City of Florence

RESOLUTION: PC 22 11 COU 01 – Wilcox Deli Change of Use

AGENDA ITEM SUMMARY / STAFF REPORT
FLORENCE PLANNING COMMISSION

**STAFF REPORT & FINDINGS OF FACT
FLORENCE COMMUNITY DEVELOPMENT DEPARTMENT
Exhibit "A"**

DATE 01-12-20	REVISIONS
LINDA DID IT DELIA ESPRESSO	
1856 37TH STREET UNIT 2	
Florence, Oregon 97439	
LODY CONSTRUCTION AND DESIGNS	SCALE 1"=10'
P.O. BOX 1846 FLORENCE, OREGON 97439	JOB # LDI1856
(541) 590-3641	SHEET PLOT PLAN

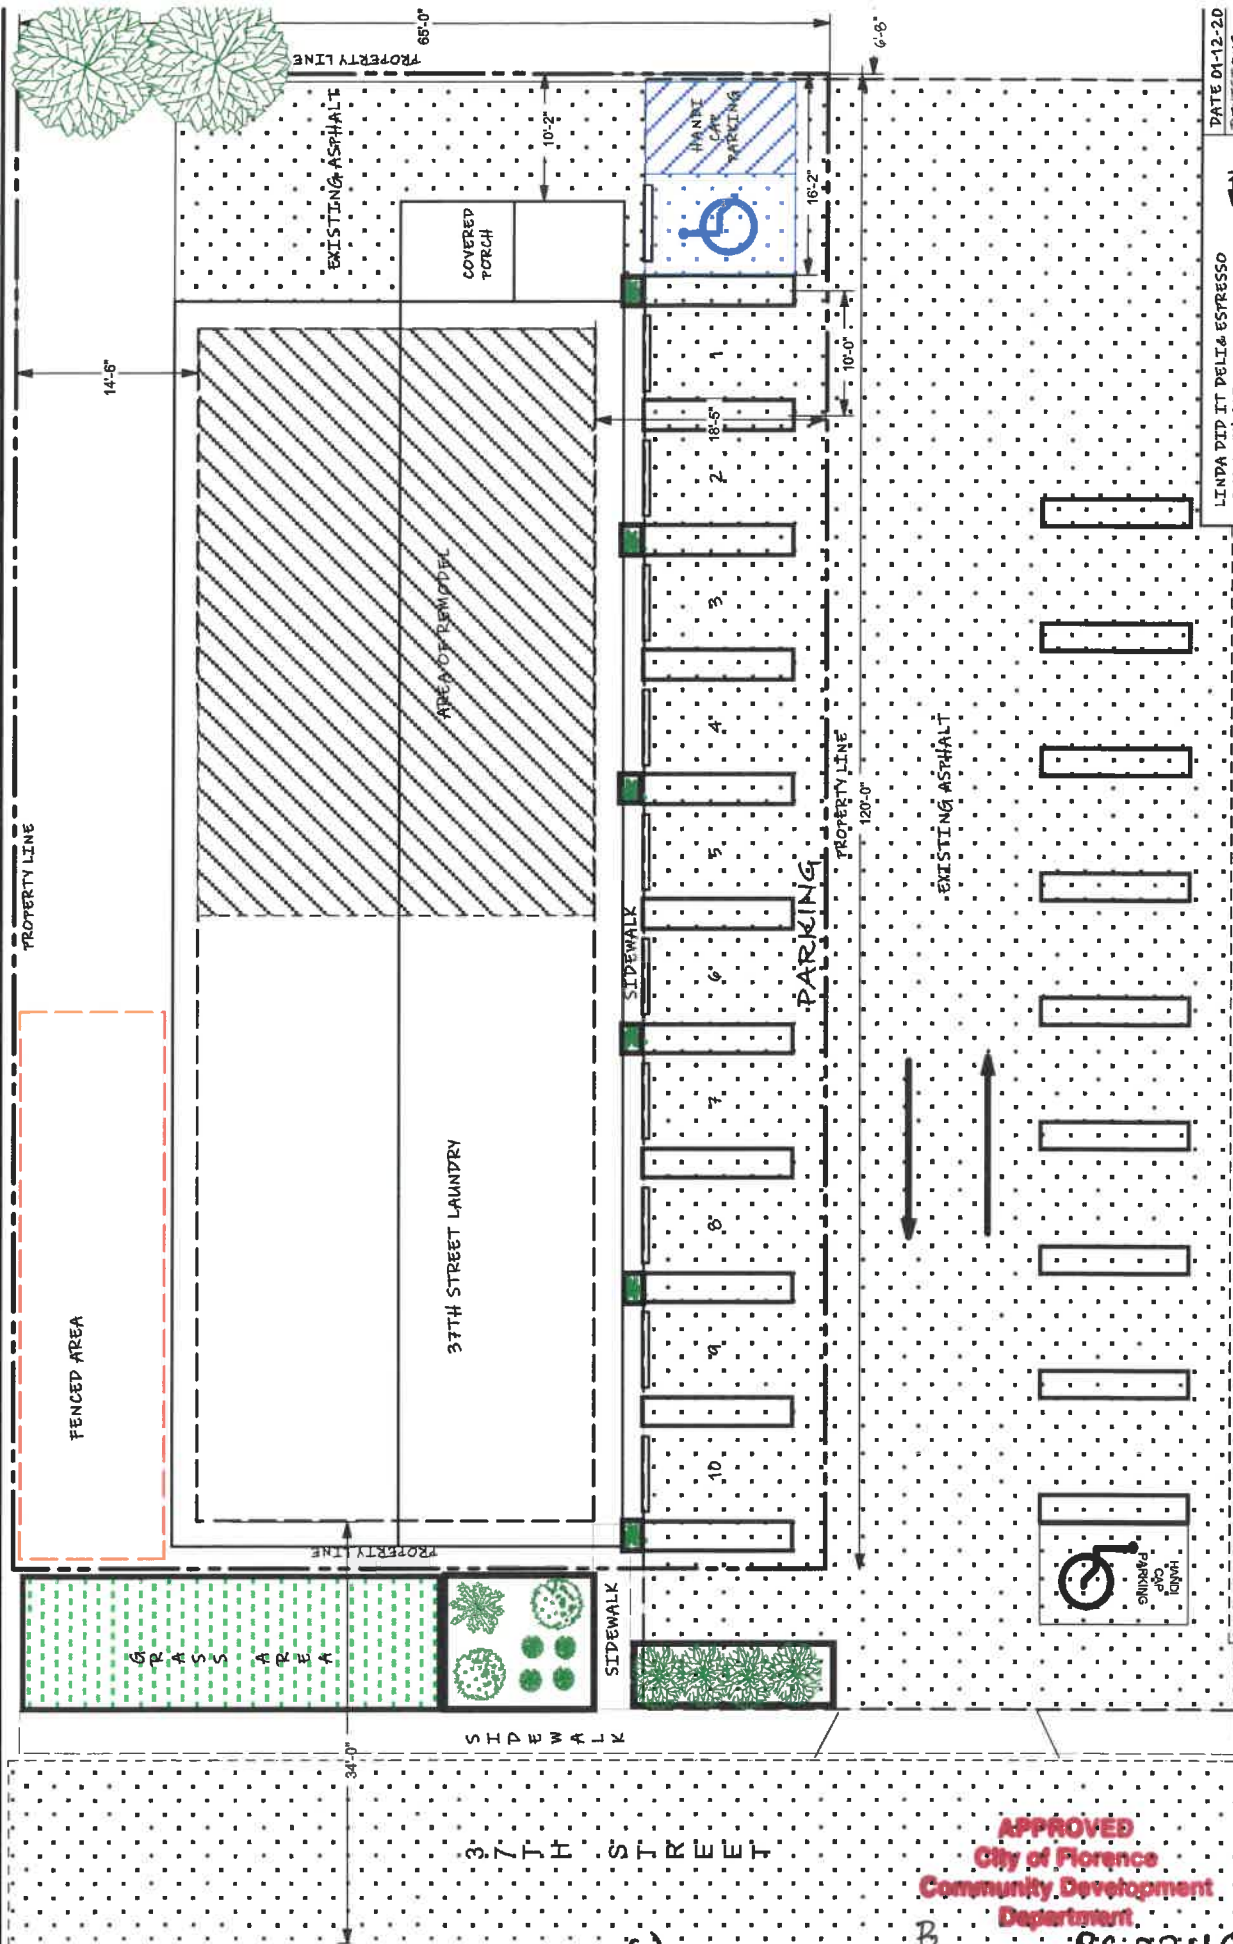
The applicant has proposed a parking and site plan. Eleven parking spaces are shown along the west side of the subject (eastern) building. One of these is an ADA van accessible space. Three of these eleven spaces shown are required for the use of the laundromat. According to RLID the laundromat contains approximately 1,696 sq. ft. The parking spaces for the laundromat are calculated using the square feet of the laundromat divided by 500 square feet (bulk retail-appliances category was used for retail service use). Restaurant use requires 1 space for every 125 sq. ft.:

The parking plan contains 18 parking spaces: 11 spaces (including the required van accessible parking space) along the west side of the eastern building and 9 spaces east of the western thrift store building. Since the thrift store requires 6 parking spaces--assuming no bulk retail, or 5 spaces if half is bulk retail, the apartment requires 2, the laundromat requires 3, and the deli requires 12 parking spaces, total required parking equals 23 or 24 spaces. The parking plan contains 20. On-street parking is allowed; however, this needs to be demonstrated, or a parking agreement established with another property within 500' of the site in accordance with 10-3-7. To meet the intent of FCC 10-3, prior to final inspection, the applicant shall supply an updated parking plan indicating one of the following: 24 parking spaces provided; or provide a thrift store floor plan illustrating half the floor area is bulk retail sales and an updated parking plan indicating 23 parking spaces. The approved plan shall be implemented prior to issuance of final inspection. (Condition 4.1)

4.1 To meet the intent of FCC 10-3, prior to final inspection, the applicant shall supply an updated parking plan indicating one of the following: 24 parking spaces provided; or provide a thrift store floor plan illustrating half the floor area is bulk retail sales and an updated parking plan indicating 23 parking spaces. The approved plan shall be implemented prior to issuance of final inspection.
